**U.S. FOREST SERVICE  
NATIONAL STREAM AND AQUATIC ECOLOGY CENTER**

**August 16, 2016**

**ARMSTRONG CREEK RESTORATION: ASSESSMENT**

**Client:** Routt National Forest

**Figure 10:** Perched constructed stream channel, with adjacent floodplain and ponds constructed where the incised channel was located prior to restoration.

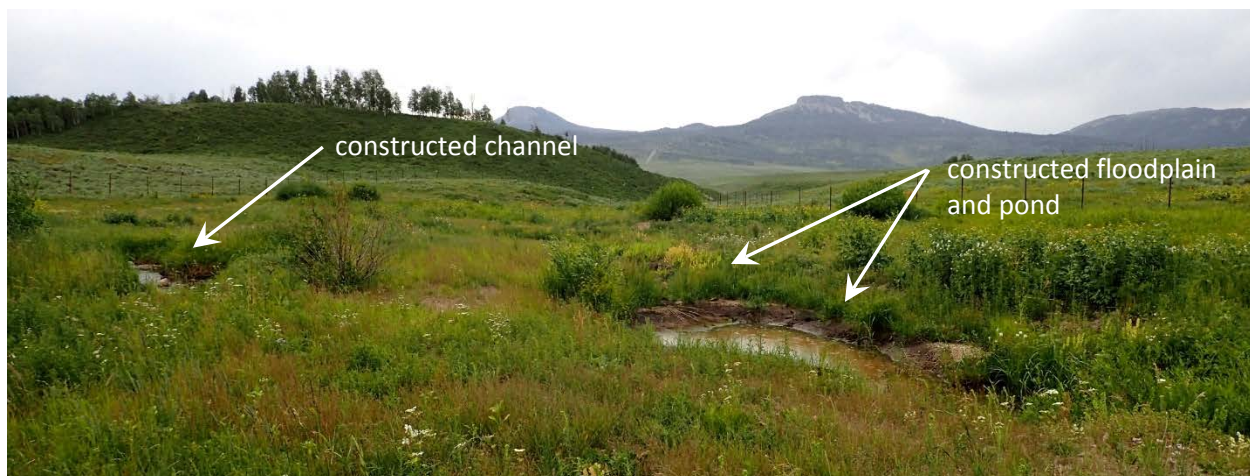
- The new channel and immediately adjacent floodplain surface appear to be perched above the floodplain and a series of small ponds were established where the incised channel existed prior to construction (Figure 10). Some headcutting of the plugs installed between the ponds, with resulting loss of water holding capability, was observed. This elevation difference may result in recapture of the stream channel.
- The earthen berms separating the new channel from the ponds and location of the previously-incised channel (Figure 9) are narrow and likely too dry for sedge establishment. Willow revegetation efforts were not utilized in these areas. Reportedly, these berms are designed to be overtopped with flows greater than the 5-year return interval.

- The grading of the valley bottom and constructed channel (Figure 10) is likely not sustainable, with the pond area (where the

former incised channel was located) and floodplain being at a lower grade than the channel. Fundamentally, floodplains slope up from a channel and adjacent bankfull surface. When the berms separating the channel from these pond areas are overtopped (>5-year return interval flood), there is high risk of this resulting in channel capture of the new channel by the old. This would result in a straightening, steepening, bypassing of the constructed grade-control structures, headcutting and incision, and the likely reformation of the pre-restoration gully (Figure 15).

piping. Additionally, borrow material from a nearby source would be used to fill and regrade the pond areas (Figure 10) so that an increasing floodplain slope away from the channel results. This area would be then revegetated with sedges and willows, to provide long-term stability and ecological value. Additionally, with the mobilization of heavy machinery to the site, patching and revegetating other ongoing geomorphic adjustments should be performed, including the headcuts propagating across the floodplain surfaces, lost riffle bed material (Figure 11), resulting headcutting (Figure 13), and local erosion occurring downstream from the rock and roll structures (Figure 14) and the upstream coir and toe wood structures (Figure 8).
